WATER PERMIT NO. 6634-3

Application For Permit To Appropriate Water Within The State Of South Dakota

I'm writing as a follow up to the phone conversation we had yesterday regarding the plans and specifications for the two dams associated with Water Permit Nos. 6633-3 and 6634-3 for PJ Werdel & Sons, Inc. The follow is a summary of the items we discussed.

Irrigation Pond Addendum
PJ Werdel & Sons, Inc.
Part of S19 & 20, T109N, R70W - Hand County

CROSS SECTION AA

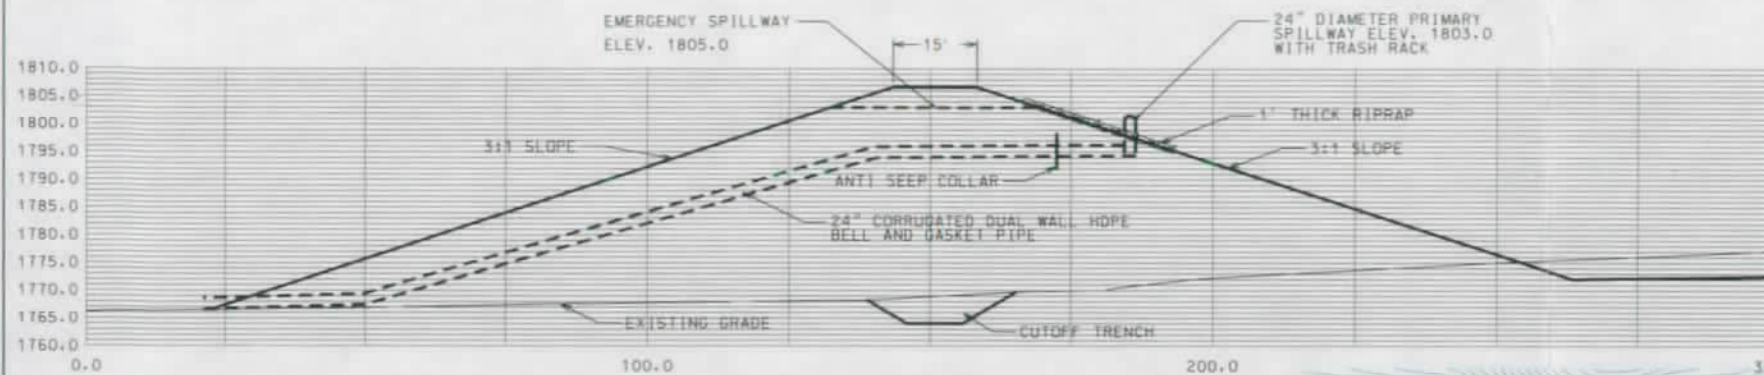
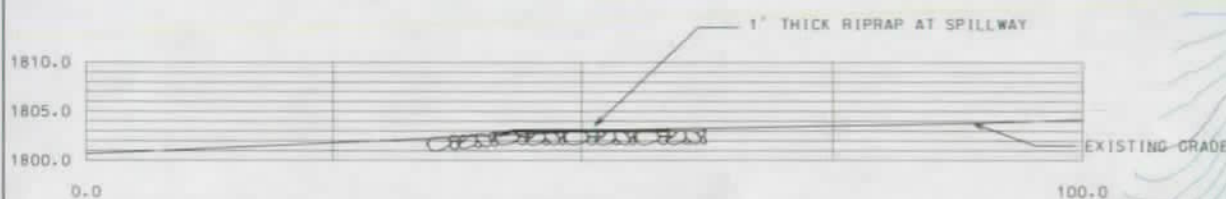
2. We discussed using 3 feet of freeboard on the emergency spillways for both dams instead of only 2 feet as shown on the plan sheets and stage storage data. Along with that, we discussed the fact that the elevations for top of dam, secondary spillway and primary spillway for the West Dam on the plan sheet Cross Section BB and the elevations used on the stage storage data page do not match up. You indicated the elevations on the stage storage page should be the correct elevations; however, to reflect the 3 foot freeboard change you will need to submit new cross sections and stage storage data for both dams.

1. I have changed the return period to 50 year and the calculations were correct. I have also included a copy of the IDF curves used for the calculations.
2. The spillways for both ponds now provide 3 feet of depth.
3. After talking with South Dakota Concrete Products about their concrete risers, I am not comfortable with the joint from concrete to HDPE or the trash rack that they can provide. Therefore, I have proposed using the HDPE risers with a concrete case poured around them.
4. I have provided cross sections and capacity calculations for the diversion ditch which transfers water over to the west dam.
5. The management of this facility would like to leave the existing dam as it is today to help settle any sediment out before it reaches the new irrigation pond. They will place riprap in the existing spillway to provide erosion protection.

WEST IRRIGATION POND
PJ WERDEL & SONS INC.
NE 1/4, SEC 19, T 109 N, R 70 W
NE 1/4, SEC 20, T 109 N, R 70 W
HAND COUNTY
SETTJE AGRI SERVICES
AND ENGINEERING, INC.

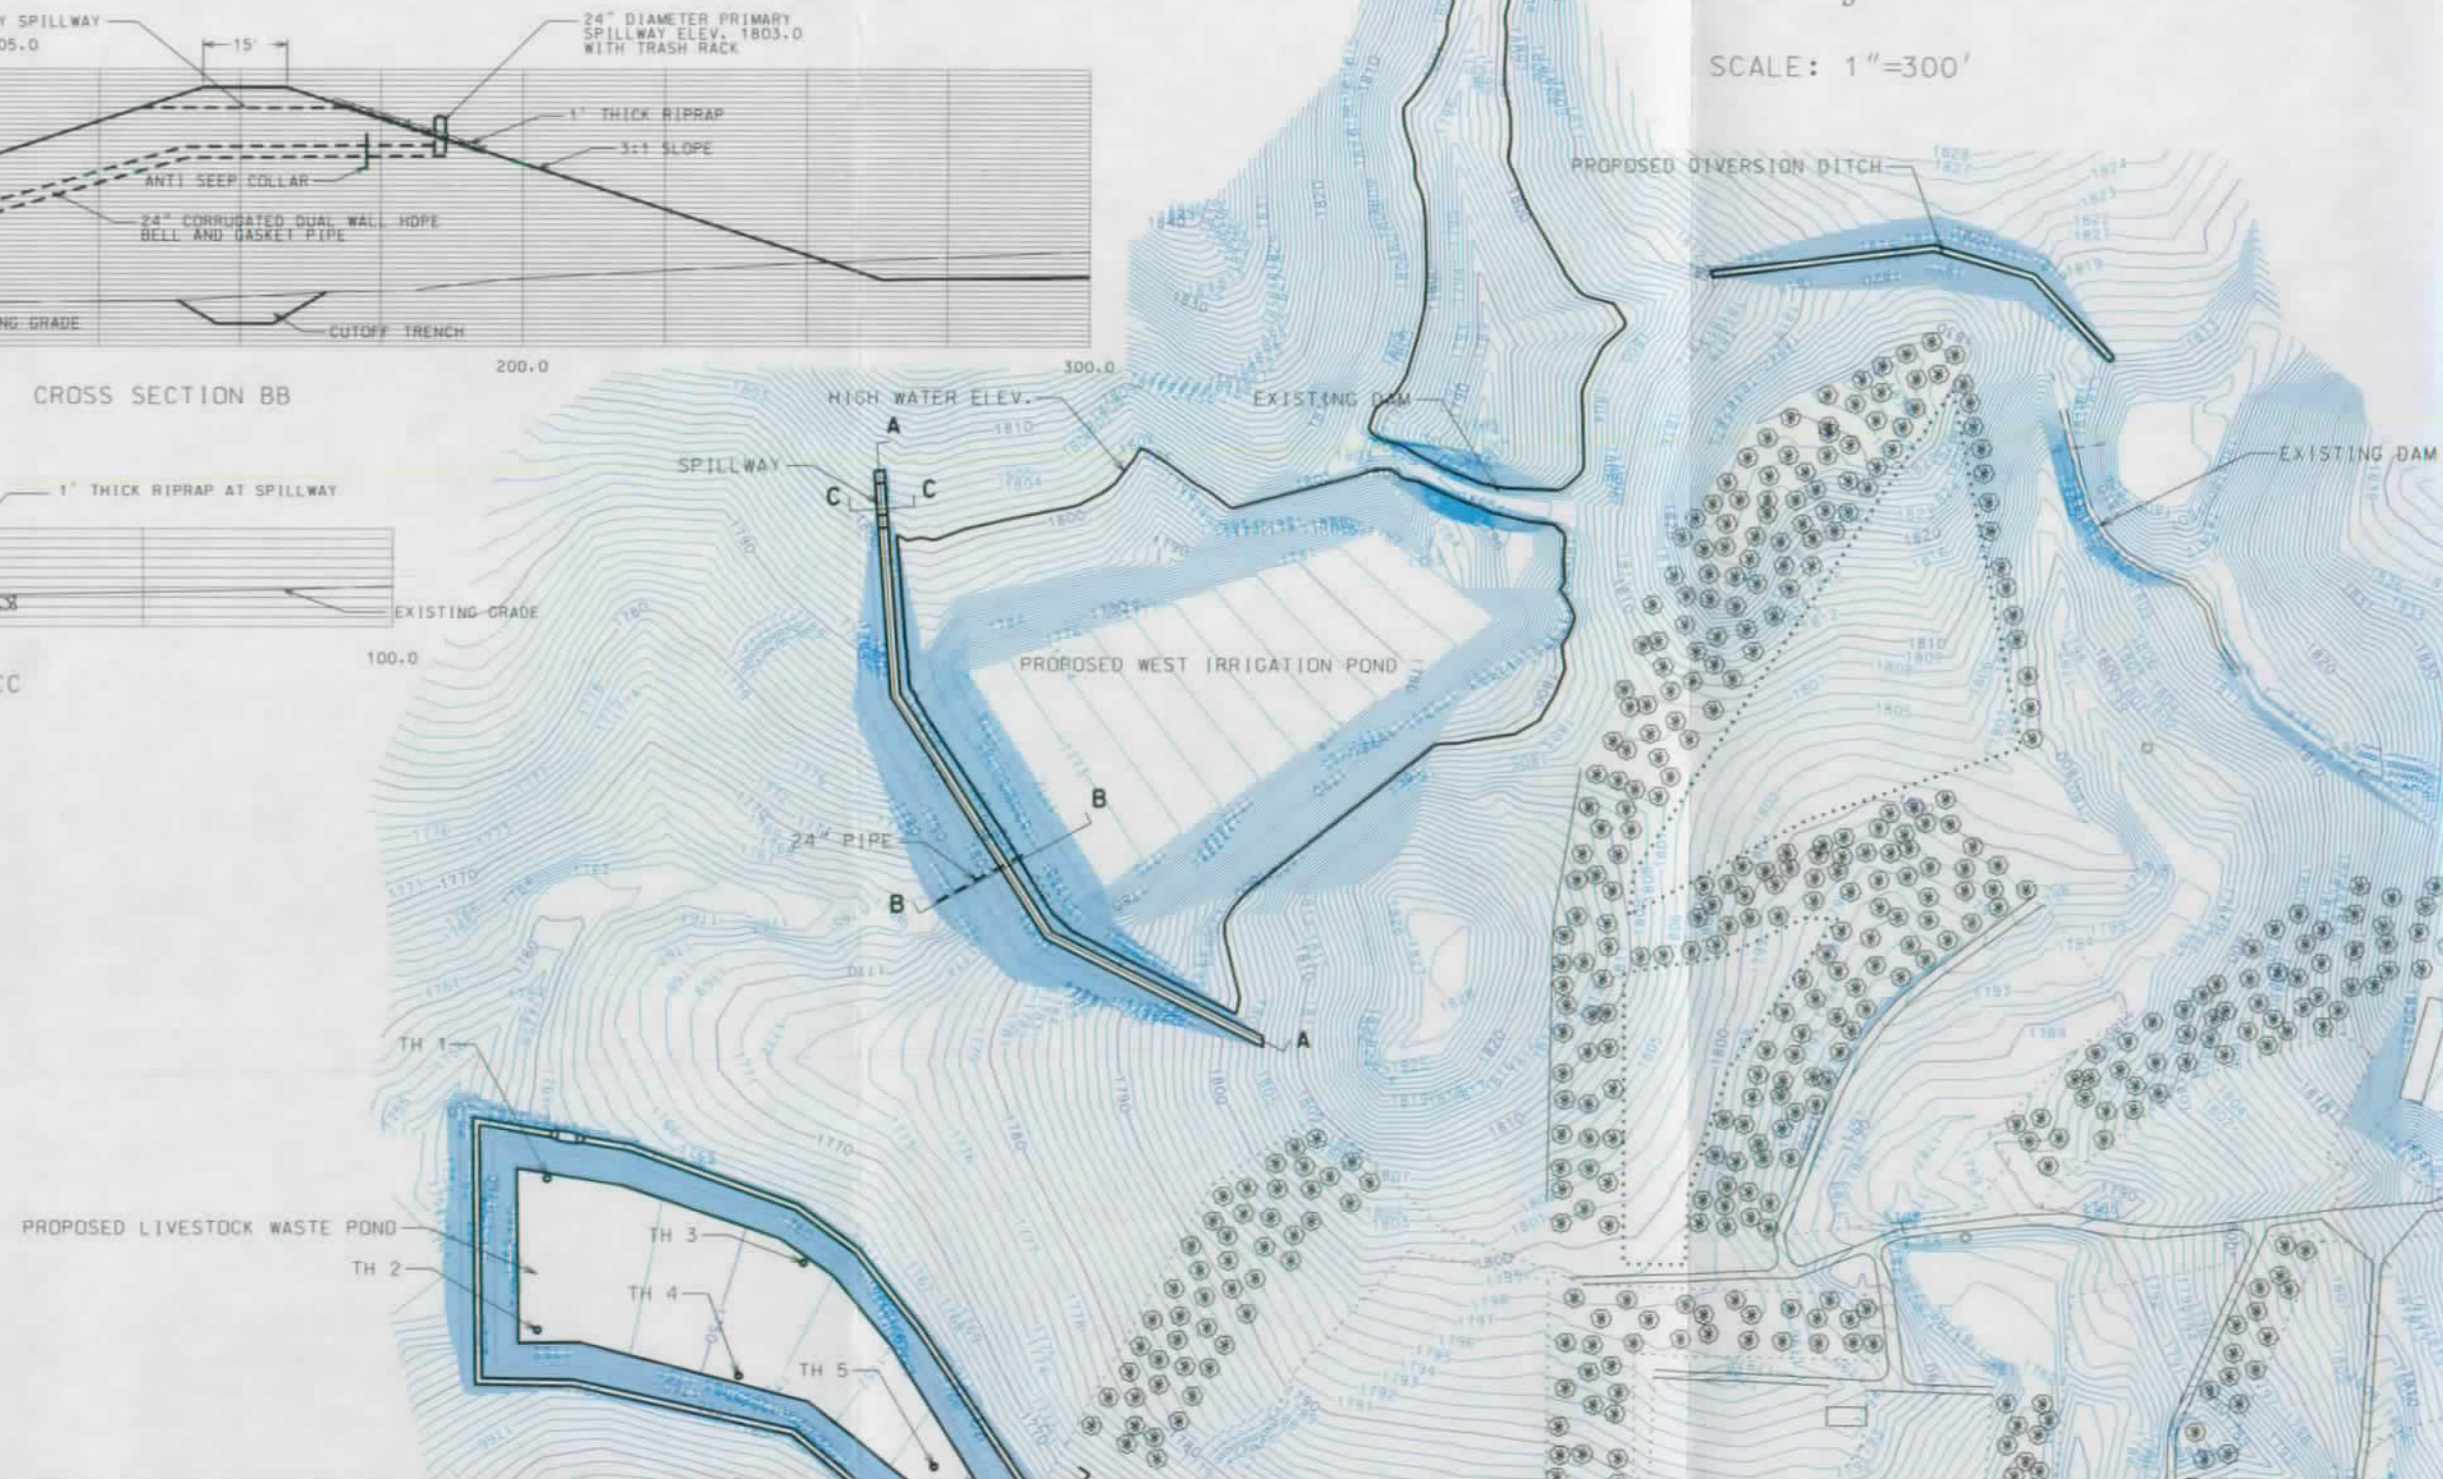
1. In your cover letter dated June 22, 2005 you reference that both dams were designed for 50-year, 24 hour events; however, the Waterway Capacity Calculations data indicates a return period of 25 years was used. You indicated that you thought the calculations were correct and only needed to change the return period figure, however, you would double check the calculations along with sending me copies of your reference material for these calculations.

3. Instead of using the HDPE pipe as the primary spillway risers, we discussed using a concrete riser on both dams similar to what I see on NRCS designed dams in South Dakota. Enclosed is a copy of a set of NRCS plans illustrating what I would like to see incorporated in your design and shown on the plan sheets. I checked with the NRCS and they get the pre-cast risers from South Dakota Concrete Products in Rapid City (605-343-1450).

4. You indicated you would send size and elevation information on the breach and/or diversion ditch from the east dam transferring that drainage over to the west dam.

5. And finally, we discussed the existing dam just upstream of the West Dam. You indicated that you did not include the upper dam's storage capacity in the Water Permit Application since it will be unavailable to use with the pump being located in the lower reservoir. My concern with this is that with the additional drainage area diverted into the upper dam from the east, the existing spillway located at the west end of the upper dam will eventually eroded to where both reservoirs are connected or there may be times during low runoff years that the Werdel's may want the two reservoirs connected. You indicated you would talk this over with Mr. Werdel and maybe try to connect the reservoirs with an additional pipe. If so, that detail should be included on the plan sheets and the storage capacity for Water Permit Application No. 6634-3 (West Dam) should be changed to include both reservoirs.
